Subject: Final meeting notes with attachments for PEF/LNP Meeting on 01/19/2012
(UNCLASSIFIED)
Sent Date: 1/30/2012 1:18:36 PM
Received Date: 1/30/2012 1:20:53 PM
From: Hambrick, Gordon A SAJ

Meeting Subject: Progress Energy Florida/Levy Nuclear Plant – SAJ-2008-00490(IP-GAH)

Levy Nuclear Plant Monitoring Plan Recommendations

Figure 1 – Map of Surficial Aquifer System Drawdown from 5 layer Model

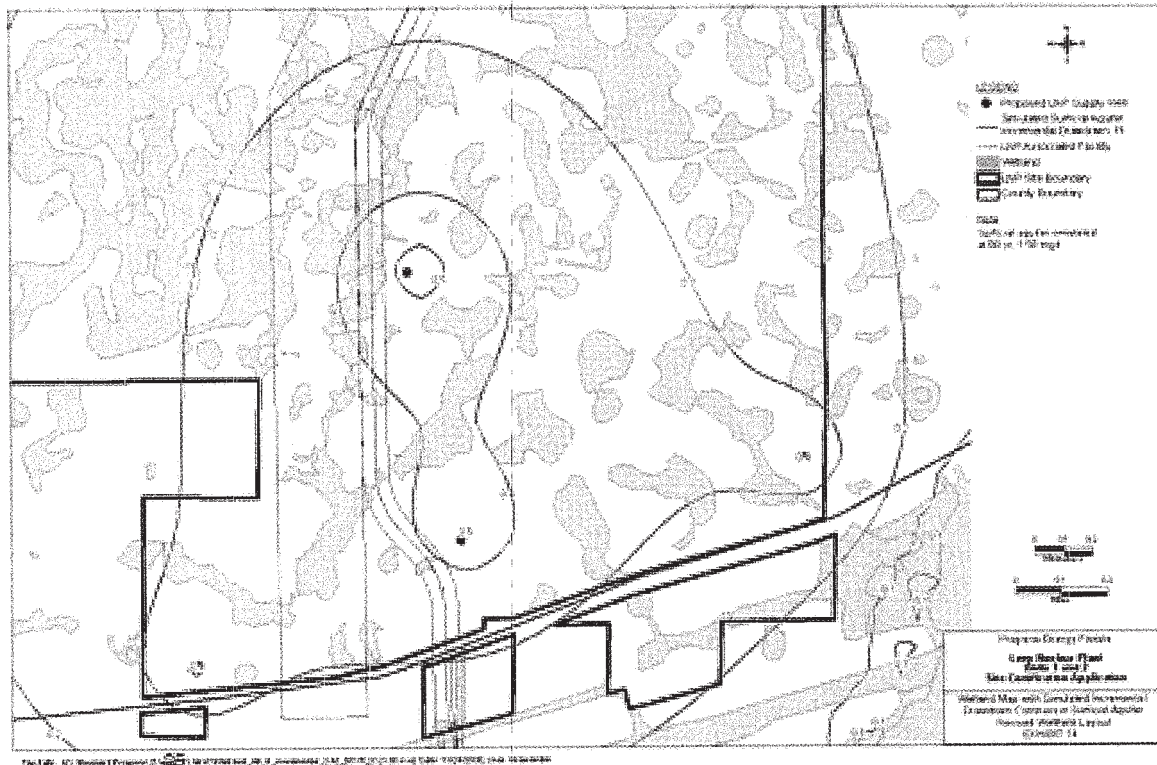
PEF proposes to have four water supply wells constructed (Figure 1) that will withdraw on average 1.5 million gallons per day (mgd) and up to 5.8 mgd during peak periods of energy use. Excessive groundwater withdrawals are known to have detrimental impacts on hydrology and the ecology of the overlying wetlands (Hoffstetter, 1990; Sonenshein, 1990). While the landscape in the project area of influence is not pristine and has been impacted by silviculture and the Cross Florida Barge Canal, areas within the project footprint have been categorized as wetlands and thus must be conserved in both form and function [Clean Water Act, Section 404(b)]. Modeling scenarios were completed by PEF at the direction of the Southwest Florida Water Management District (SWFWMD) to analyze potential hydrological changes to the aquifer underlying the site. The scenarios estimated that drawdowns would only depress the groundwater levels by 0.4 ft in a small area immediately surrounding the wellfield (Figure 1). This model scenario was considered by us as an approximation of the spatial extent and the severity of any potential impacts to the overlying wetlands in both form and function.

Our review of the modeling assumptions for this particular modeling scenario indicates that it does not provide sufficient information (low confidence) to make any definitive decisions on the type and extent of impact the proposed groundwater withdrawals would have on the overlying wetlands. The model results provide a very coarse temporal resolution of the drawdown effects because they are averaged over 60 years. This coarse resolution does not account for changes in inter-annual/decadal precipitation and annual groundwater hydrologic patterns that reflect normal fluctuations experienced by the natural system. The periodicity and magnitude (duration and depth) of the drawdown are strong drivers shaping wetland structure (Kirkman, et al., 2000). If groundwater usage is averaged during annual hydrological periods, then the seasonal effects of groundwater drawdowns can be missed. For example, the modeled scenario does not take into account the peak water usage of up to 5.8mgd in relation to the natural hydrologic cycle that could include an unusually dry precipitation year coupled with a higher than average temperature year. As peak energy use occurs during the summer, there is an increased draw on the groundwater in excess of the 1.58mgd average and approaching the 5.8mgd maximum. Due to the lack of a normal amount of rainfall to recharge the aquifer, the groundwater levels remain at levels below the average. As the winter months ensue, the energy use once again peaks and groundwater withdrawals increase greater than the average on an already depressed aquifer causing the groundwater levels to fall even lower. The current modeled scenario does not allow us to determine the extremes that can occur in the system. It is these extremes, although they may be few and far between, that must be taken into consideration, as they can be the “tipping points” that result in greater impacts (area and degree) to the natural ecosystem from which they can’t recover.
